COMMONWEALTH of VIRGINIA

February 5, 2014

MEMORANDUM

To: All Holders of the Virginia Department of Transportation's 2008 Road and Bridge Standards

STANDARD GUARDRAIL HARDWARE

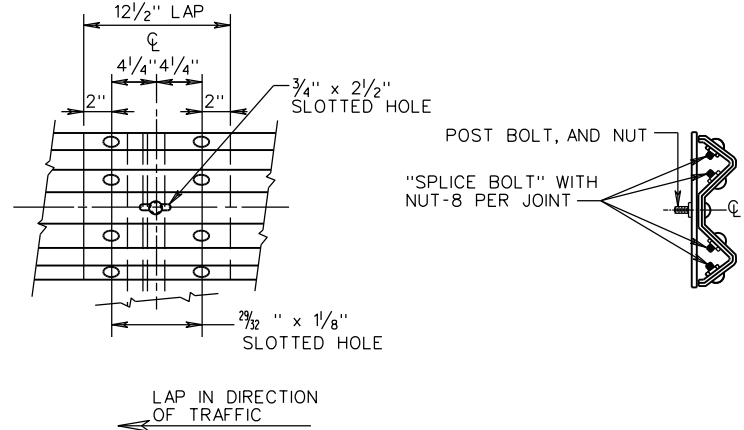
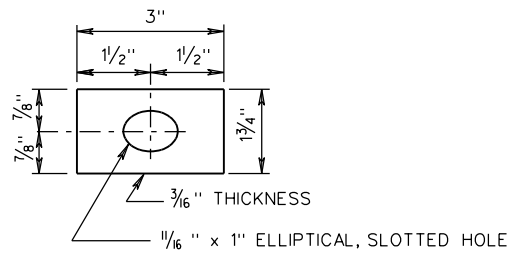
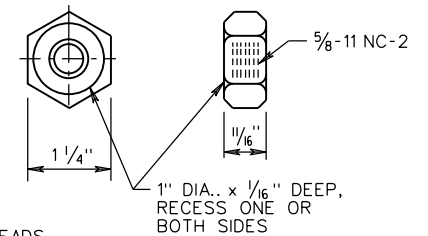
<u>PAGE</u>	<u>INTERIM</u>	<u>STANDARD</u>	<u>REVISION</u>
501.01	IIS05_04	GR-HDW	REVISED NOTE IN DETAIL OF SPLICE JOINT REMOVING WASHER ON LAST 50' ON RUN OFF END. ADDED L = 2" FOR BUTTON HEAD BOLT USED ON NESTED W BEAMS.

- L = 1 1/4" FOR SPLICE BOLT-FULL LENGTH THREADS
- L = 2" FOR SPLICE BOLT-FULL LENGTH THREADS ON NESTED W BEAMS.
- L = 10" FOR STEEL POST BOLT-1 1/2" MIN. THREADS
- L = 18" FOR WOOD AND CONCRETE POST BOLT-2 1/2" MIN. THREADS
- L = 26" FOR MB WOOD OR CONCRETE POST-2" MIN. THREADS

STANDARD BLOCKED-OUT W-BEAM GUARDRAIL
(STRONG POST SYSTEM, POST AND BLOCKOUT DETAILS)
 VIRGINIA DEPARTMENT OF TRANSPORTATION

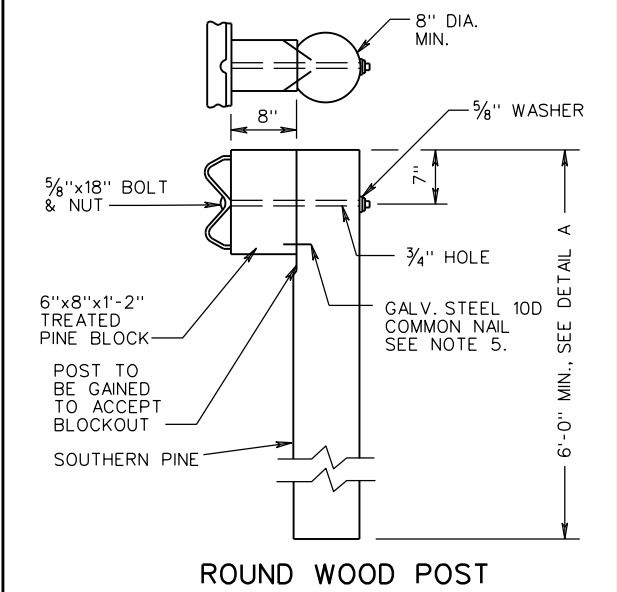
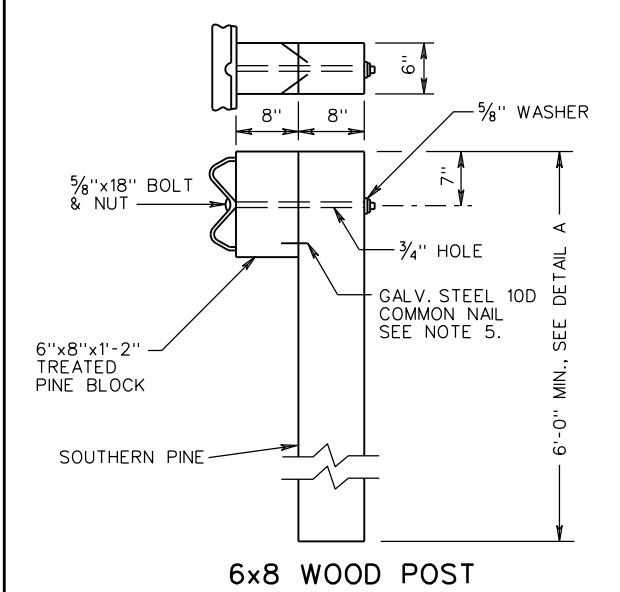
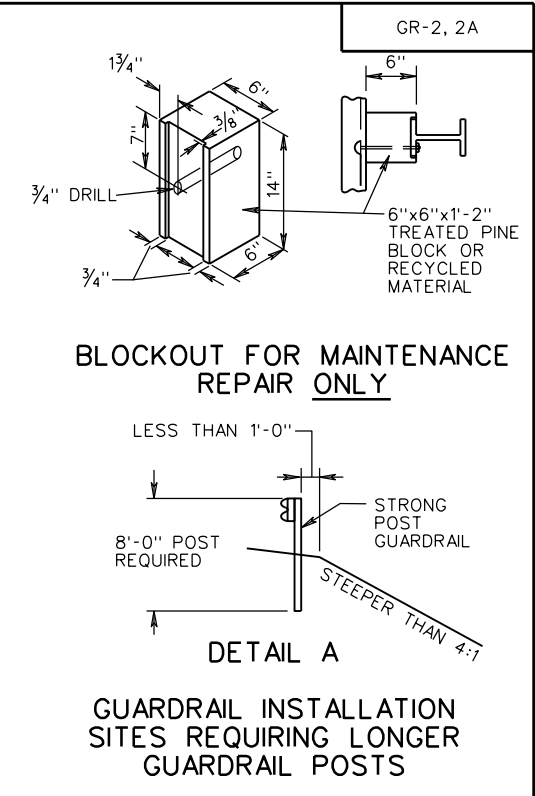
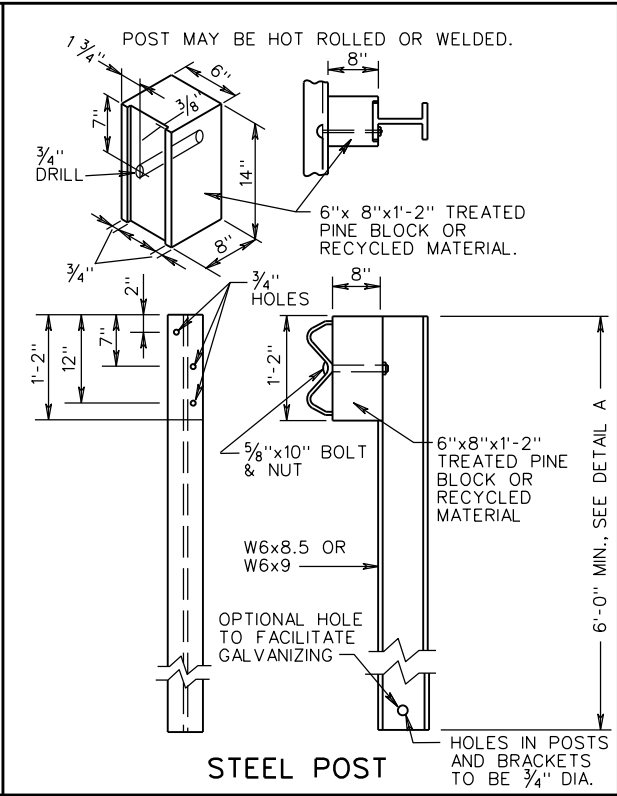
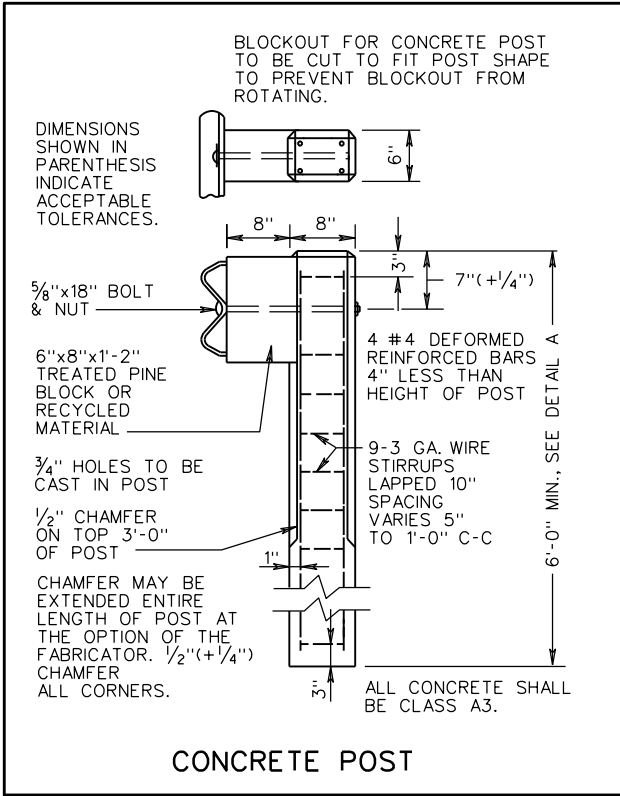
<u>PAGE</u>	<u>INTERIM</u>	<u>STANDARD</u>	<u>REVISION</u>
501.05	IIS05_10	GR-2, 2A	ADDED NOTE ON WOOD POSTS 5/8" WASHER REQUIRED
501.13	IIS05_23	GR-7	ADDED NOTE "TRANSITION TO PROPOSED SLOPE" AND REPLACED "HINGE" WITH "TOE OF SLOPE" IN PLAN VIEW

A COPY OF THE ORIGINAL SEALED AND SIGNED DRAWING IS ON FILE IN THE CENTRAL OFFICE.
GUARDRAIL TERMINAL INSTALLATION SITE PREPARATION REQUIREMENTS FOR GR-9

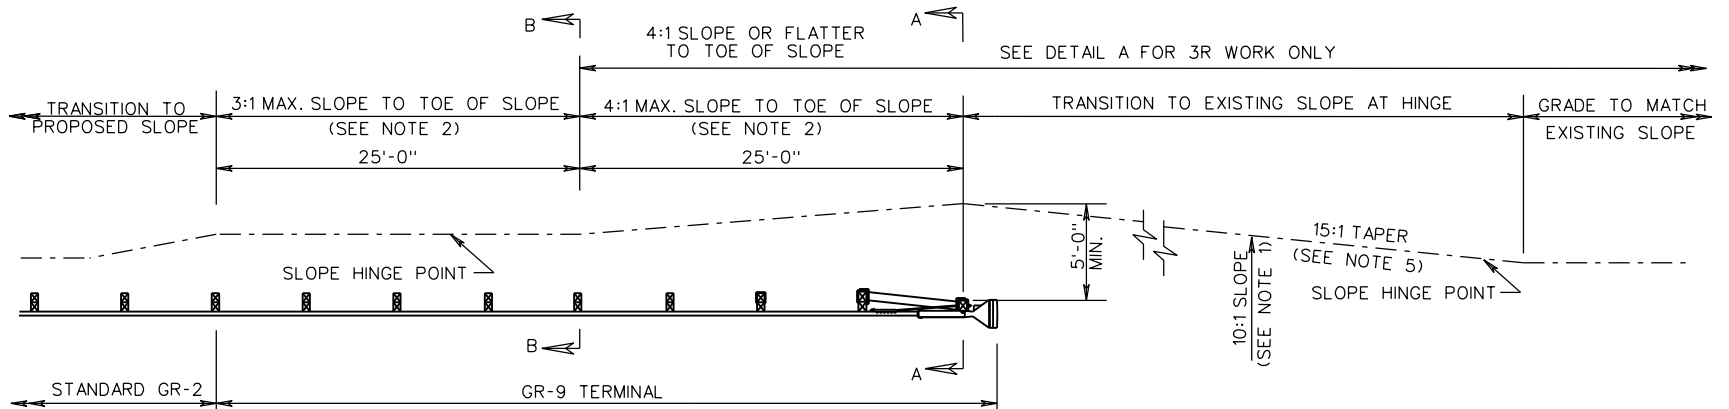
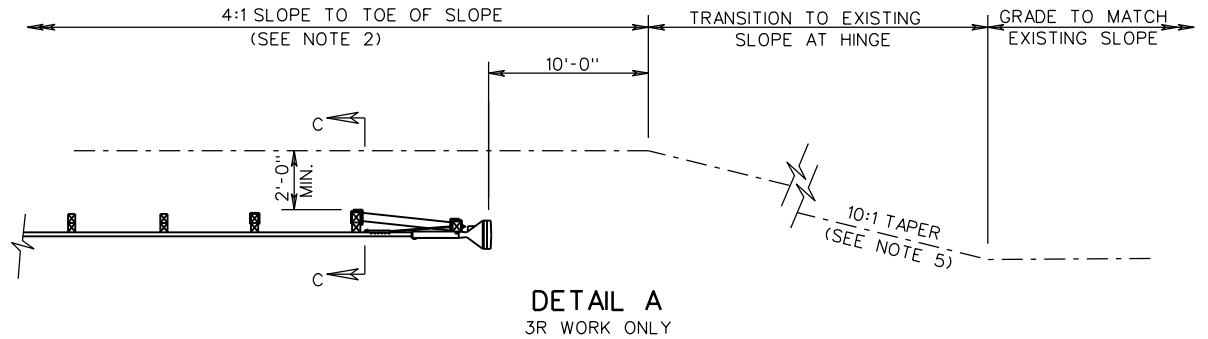
501.17	IIS05_24	GR-9	ADDED NOTE "TRANSITION TO PROPOSED SLOPE" AND REPLACED "HINGE" WITH "TOE OF SLOPE" IN BOTH PLAN VIEWS, ADJUSTED LOCATION OF SECTION B-B IN THE PLAN VEIW

A COPY OF THE ORIGINAL SEALED AND SIGNED DRAWING IS ON FILE IN THE CENTRAL OFFICE.
W-BEAM GUARDRAIL - FIXED OBJECT ATTACHMENT
 FOR USE BETWEEN VERTICAL FIXED OBJECTS AND GUARDRAIL (WOOD POSTS)
 VIRGINIA DEPARTMENT OF TRANSPORTATION

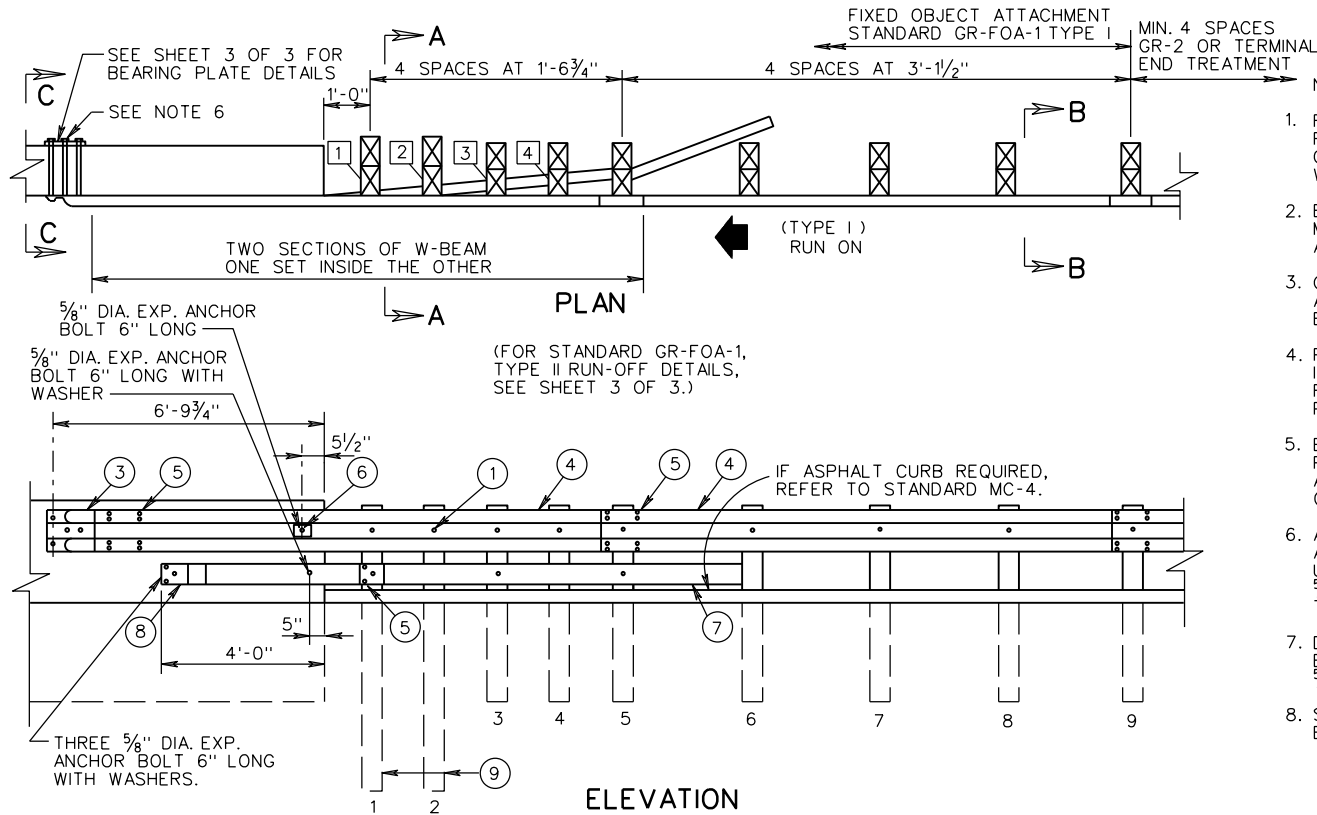
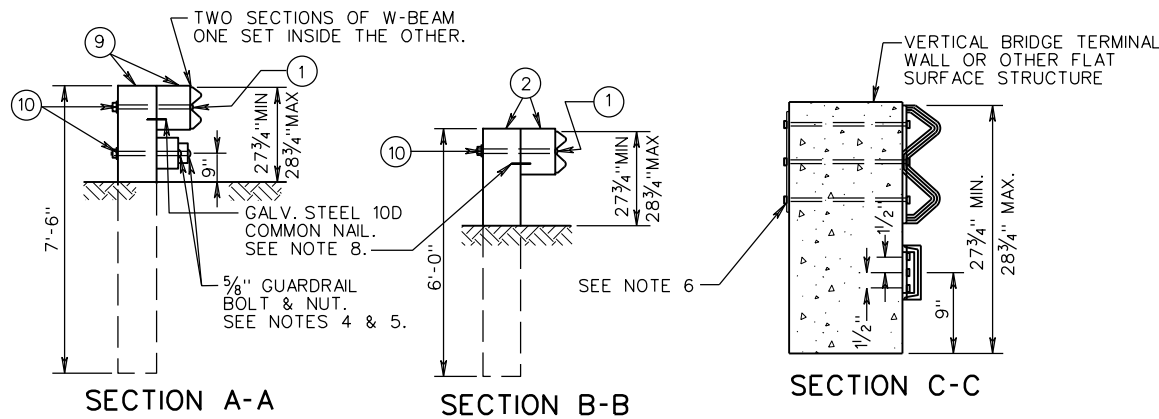
501.25	IIS05_12	GR-FOA-1	REVISED NOTE ABOUT MC-4 TO "IF REQUIRED" IN ELEVATION VIEW, SECTION A-A AND NOTE 5 CHANGED "CARRIAGE BOLT" TO "GUARDRAIL BOLT", NOTE 6 CHANGED "A325" TO "A449"

5. BOTTOM WOOD BLOCKS LOCATED ON POSTS 1 THROUGH 4 ARE CENTER DRILLED AND SECURED WITH 5/8" GUARDRAIL BOLTS (LENGTH AS REQUIRED).
 6. APPROPRIATE LENGTH 7/8" DIAMETER ASTM A449 HEX BOLTS WITH WASHERS MUST BE USED WITH THRU DRILLED HOLES AND A 5/8" BEARING PLATE ON THE BACK SIDE OF THE BRIDGE PARAPET OR TERMINAL WALL.

A COPY OF THE ORIGINAL SEALED AND SIGNED DRAWING IS ON FILE IN THE CENTRAL OFFICE.
W-BEAM GUARDRAIL-FIXED OBJECT ATTACHMENT
 FOR USE BETWEEN VERTICAL FIXED OBJECTS AND GUARDRAIL (STEEL POSTS)

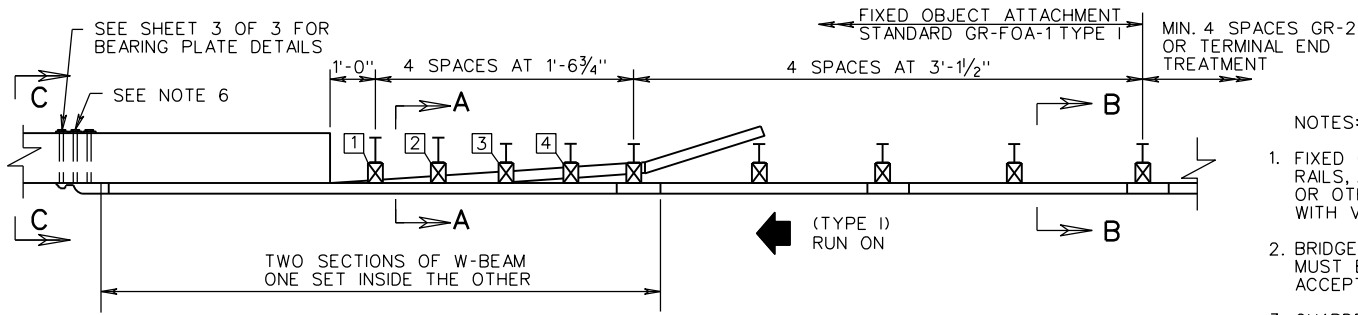
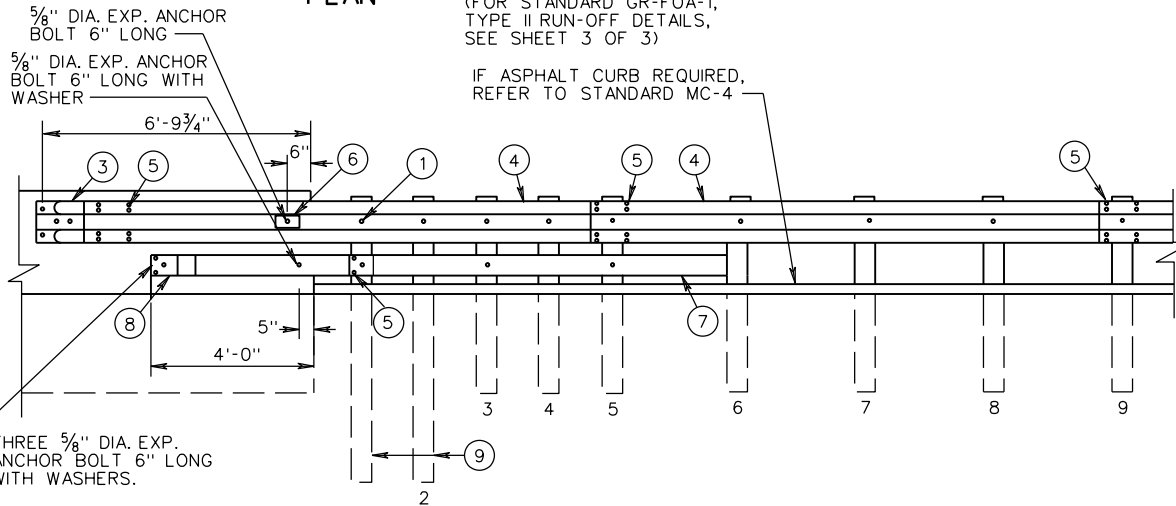
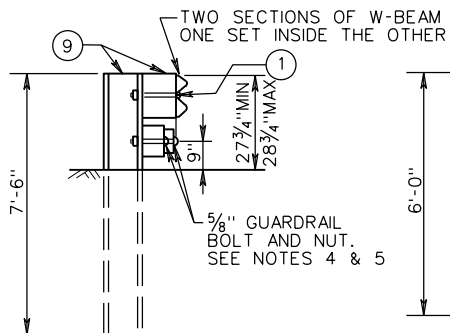
501.26	IIS05_13	GR-FOA-1	REVISED NOTE ABOUT MC-4 TO "IF REQUIRED" IN ELEVATION VIEW, SECTION A-A AND NOTE 5 CHANGED "CARRIAGE BOLT" TO "GUARDRAIL BOLT", NOTE 6 CHANGED "A325" TO "A449", REVISED ITEM 1 TO GUARDRAIL BOLT AND DELETED ITEM 10 IN THE MATERIALS LIST

IF ASPHALT CURB REQUIRED, REFER TO STANDARD MC-4

A COPY OF THE ORIGINAL SEALED AND SIGNED DRAWING IS ON FILE IN THE CENTRAL OFFICE.
W-BEAM GUARDRAIL - FIXED OBJECT ATTACHMENT
 FOR USE WITH SAFETY SHAPE - (STEEL POSTS)

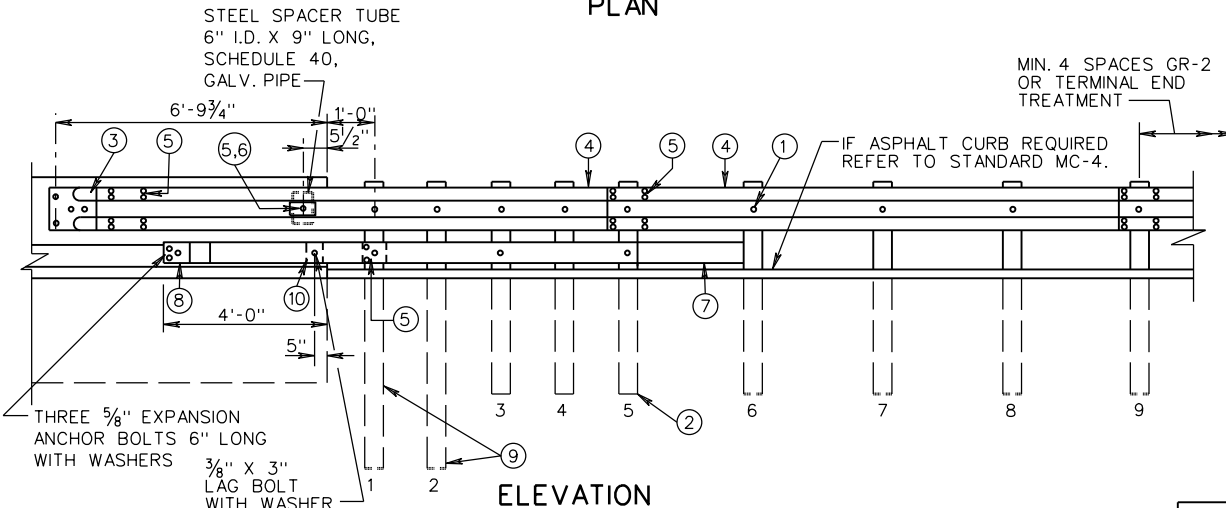
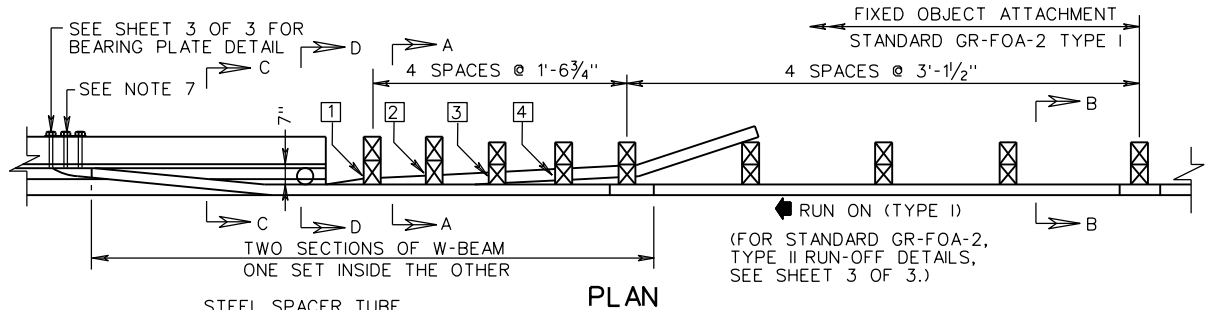
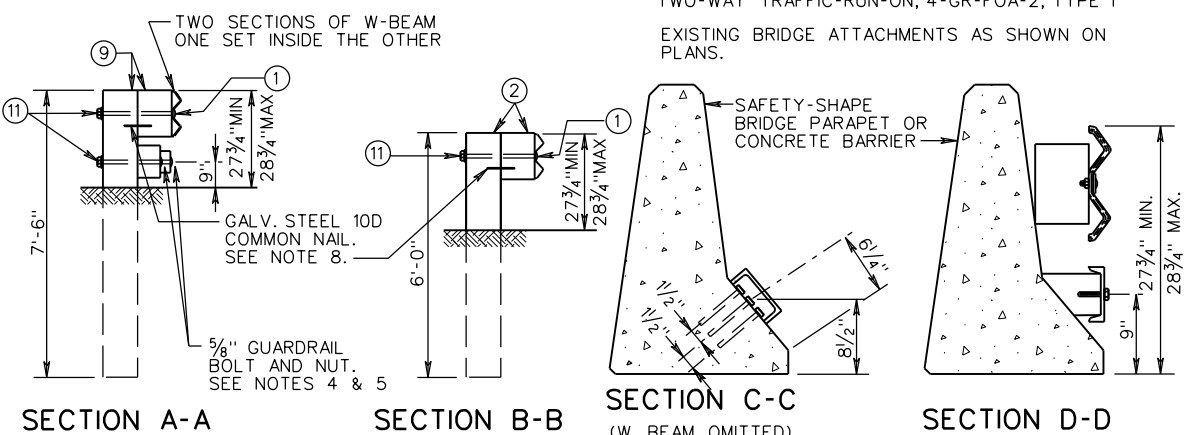
501.28	IIS05_14	GR-FOA-2	SECTION A-A AND NOTE 5 CHANGED "CARRIAGE BOLT" TO "GUARDRAIL BOLT", NOTE 7 CHANGED "A325" TO "A449", DELETED NOTE IN ELEVATION VIEW REQUIRING COMPRESSED SPACER TUBE

<u>PAGE</u>	<u>INTERIM</u>	<u>STANDARD</u>	<u>REVISION</u>
501.29	IIS05_15	GR-FOA-2	SECTION A-A AND NOTE 5 CHANGED “CARRIAGE BOLT” TO “GUARDRAIL BOLT”, NOTE 7 CHANGED “A325” TO “A449”, DELETED ITEM 1 AND REVISED ITEM 8 TO GUARDRAIL BOLT IN THE MATERIALS LIST DELETED NOTE IN ELEVATION VIEW REQUIRING COMPRESSED SPACER TUBE
501.30	IIS05_25	GR-FOA-2 & 4	DELETED W-BEAM TERMINAL CONNECTOR DETAIL, ADDED NOTE TO ITEM 8 DETAIL
501.31	IIS05_16	GR-FOA-4	NOTE 6 CHANGED “A325” TO “A449”, DELETED ITEM 1 AND REVISED NUMBERING OF MATERIALS LIST, DELETED NOTE 5 DELETED NOTE IN ELEVATION VIEW REQUIRING COMPRESSED SPACER TUBE ADDED NOTE FOR BOLTING END OF RUBRAIL TO POSTS
501.39	IIS05_08	GR-INS	REMOVED “4:1 SLOPE MAX” FROM DETAIL AT BOTTOM OF PAGE, REVISED DESIGN SPEED NOTE FOR GR-2 INSTALLATION WITH CG-3 OR CG-7 CURB

7. APPROPRIATE LENGTH 7/8" ASTM A449 HEX BOLTS WITH WASHERS MUST BE USED WITH THRU DRILLED HOLES AND A 5/8" BEARING PLATE ON THE BACK SIDE OF THE BRIDGE PARAPET OR CONCRETE BARRIER.

7. APPROPRIATE LENGTH 7/8" ASTM A449 HEX BOLTS WITH WASHERS MUST BE USED WITH THRU DRILLED HOLES AND A 5/8" BEARING PLATE ON THE BACK SIDE OF THE BRIDGE PARAPET OR CONCRETE BARRIER.
